**City of Richmond**  
Planning and Development Department

**Report to Committee**

To: Planning Committee  
From: Wayne Craig  
Acting Director of Development  
Re: Application by JJC Developments Ltd. for Rezoning at 11571 Williams Road from Single-Family Housing District, Subdivision Area E (R1/E) to Single-Family Housing District (R1-0.6)

To Council - Sept 10, 2007  
To Planning - Sep 6, 2007  
Date: August 7, 2007  
RZ 06-331192  
File: 12-8060-20-8286

DWG No. 2973-TREE

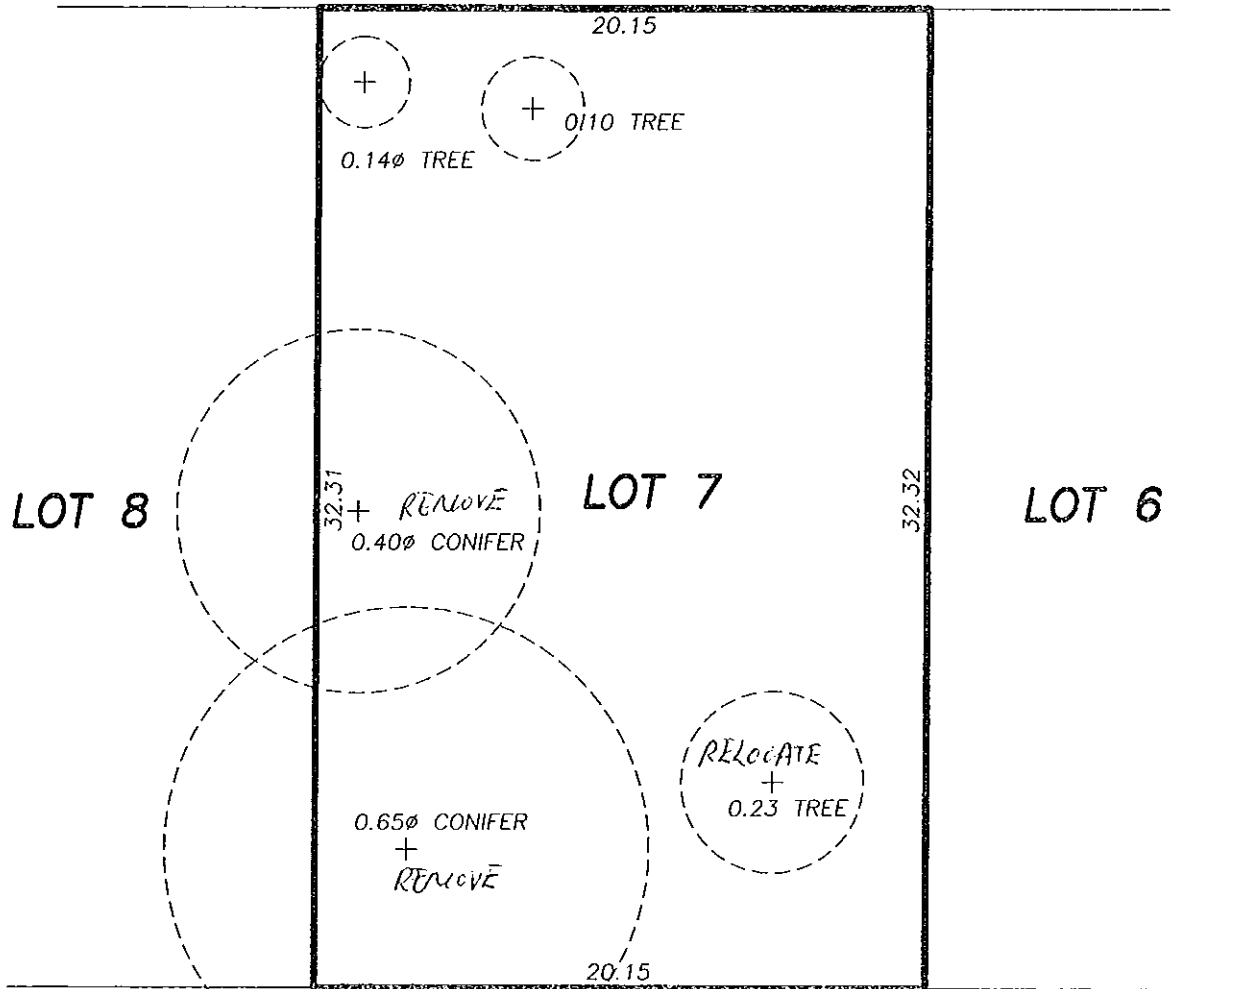
A tree survey is submitted (**Attachment 3**) and three (3) bylaw-sized trees are noted on site. The applicant is proposing to remove the Deodar Cedar and Douglas Fir and relocate the Japanese Maple tree on site to accommodate future single-family dwellings and garages. An Arborist Report prepared by a Certified Arborist is submitted in support of the tree removal and relocation (**Attachment 4**).

Tree Preservation Group staff have reviewed the Arborist Report and confirmed that the Deodar Cedar tree in the front yard is in good form and health but would be impacted by raising the grade of the front yard to match the sidewalk grade along Williams Road. In order to compensate the loss of this large Deodar Cedar tree, the applicant is proposing to plant four (4) Maple trees, each at 11 cm calliper, in the front yards of the proposed lots. Due to the grade changes and the applicant's commitment to replant large trees in the front yard to enhance streetscape, staff feel that replanting is a more appropriate approach and have no objection to the proposal of removing the large Deodar Cedar tree.

Tree Preservation Group staff have also agreed to the transplant of the Japanese Maple tree on site. This tree is not very high but it has a rather broad canopy. Tree placement must consider the spread of the tree's canopy to avoid conflict with driveways, sidewalks and structures. As a condition of this rezoning application, the applicant is required to provide proof of a contract with a company specializing in tree relocation to undertake the transplant of the Japanese Maple tree with proper removal, storage, and replanting techniques. The applicant must also submit a Survival Security to the City in the amount of \$1,000 to ensure the successful relocation of the Japanese Maple tree prior to final adoption of the rezoning bylaw.

Based on the 2:1 tree replacement ratio goal stated in the Official Community Plan (OCP) and according to the size of replacement tree requirement of the Tree Protection Bylaw No. 8057, two (2) replacement trees each at 9 cm calliper are required for the removal of the Douglas Fir tree on site.

- Provide a proof of a contract with a company specializing in tree relocation to undertake the transplant of the Japanese Maple tree with proper removal, storage, and replanting techniques. The contract must be reviewed by and to the satisfactory of the City's Tree Preservation Group;

- Provide a Survival Security to the City in the amount of \$1,000 to ensure the successful relocation of the Japanese Maple tree. 50% of the security will be released upon successful relocation and 50% of the security will be release one year after final inspection of the Building Permit in order to ensure that the Japanese Maple tree has survived;

**TREE RETENTION PLAN**

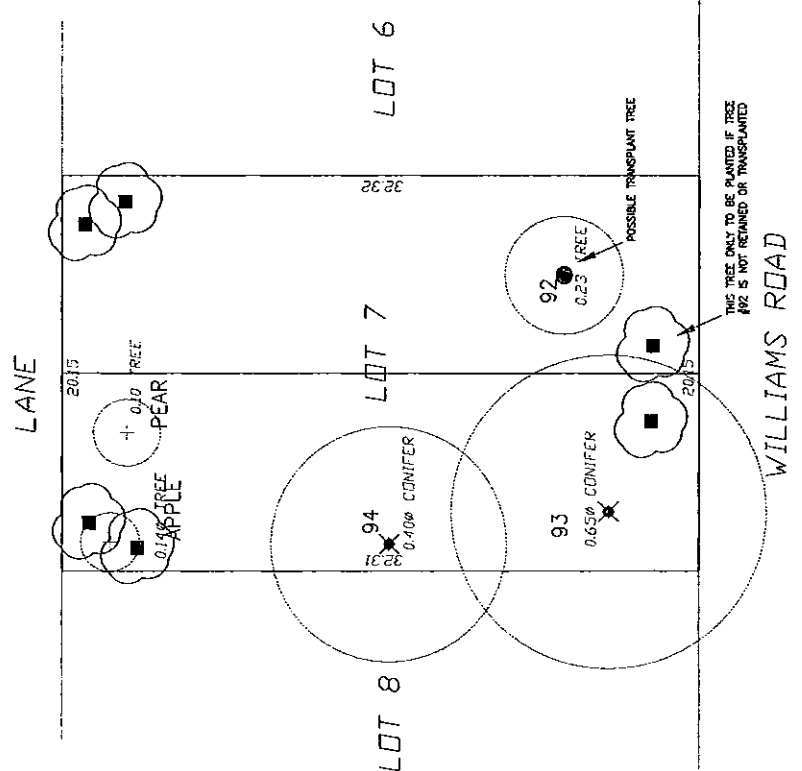
**Tree #92:** This ornamental maple tree has normal structure for the species and is suitable to be retained and protected in its present location, or if the building or re-grading of the site are in conflict, the owner may wish to transplant it to a suitable location and proper finished grade. If it is to be transplanted, a qualified tree mover must be used and the owner must care for it adequately through an establishment period. The tree will require watering, possible some fertilization and protection for at least two growing seasons.

**Tree #93:** Considering the health and structural condition of this true cedar tree, I recommend that this tree be removed. It will never regain normal structure and eventually it will become a hazard to the site.

**Tree #94:** This tree is in fair condition, however it is located fully within the building envelope. It must be removed to accommodate the new building.

LANDSCAPE PLAN

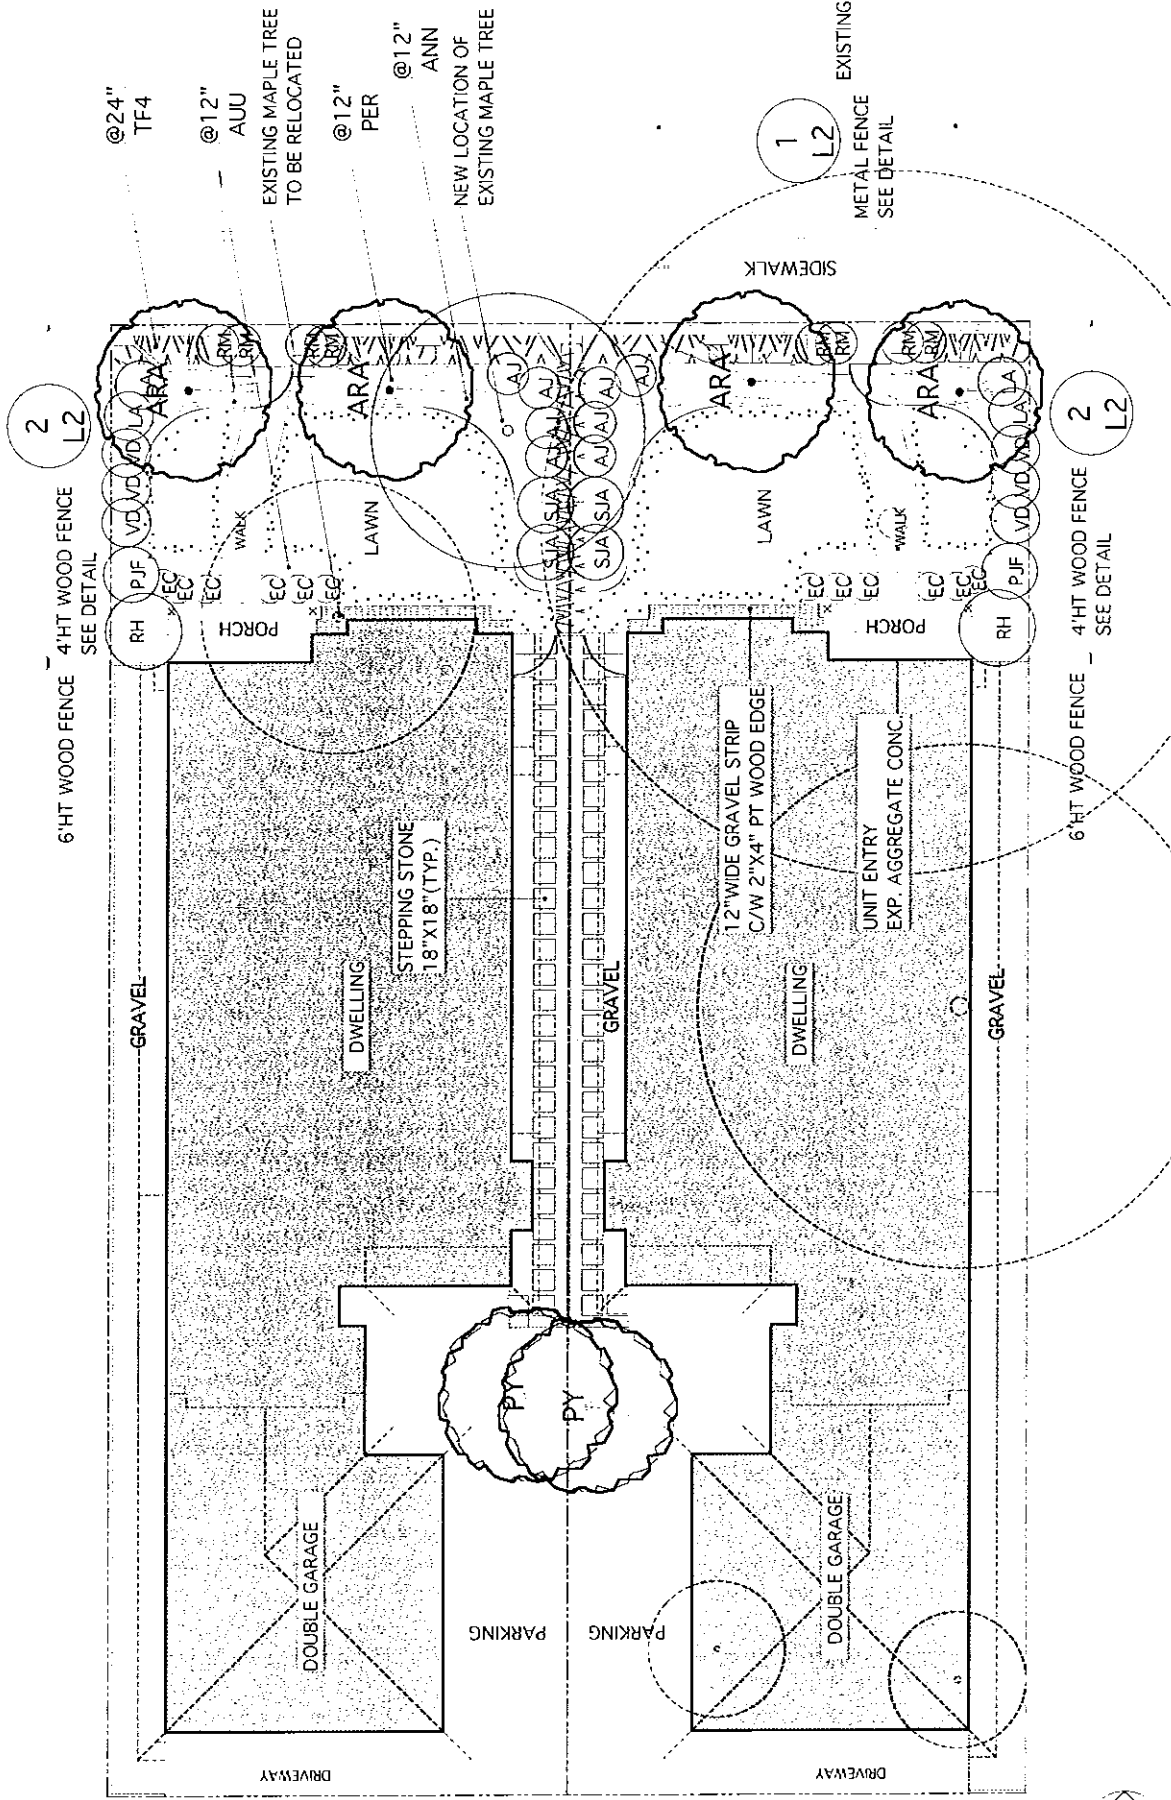
In order to ensure that the replacements will be planted and the front yards of the future lots will be enhanced, a landscape plan (**Attachment 5**) prepared by a registered landscape architect is submitted. The landscape plan includes a total of six (6) replacement trees and a combination of shrubs and ground covers in the front yard. In order to ensure that this work is undertaken, the applicant has agreed to provide a landscape security in the amount of \$7,170.00 prior to final adoption of the rezoning bylaw.

- Provide a Landscape Security to the City of Richmond in the amount of \$7,170.00 for the landscape works as per the landscape plan prepared by Ito & Associates, dated July 17, 2007, and attached to the Report to Committee dated July 20, 2007; and
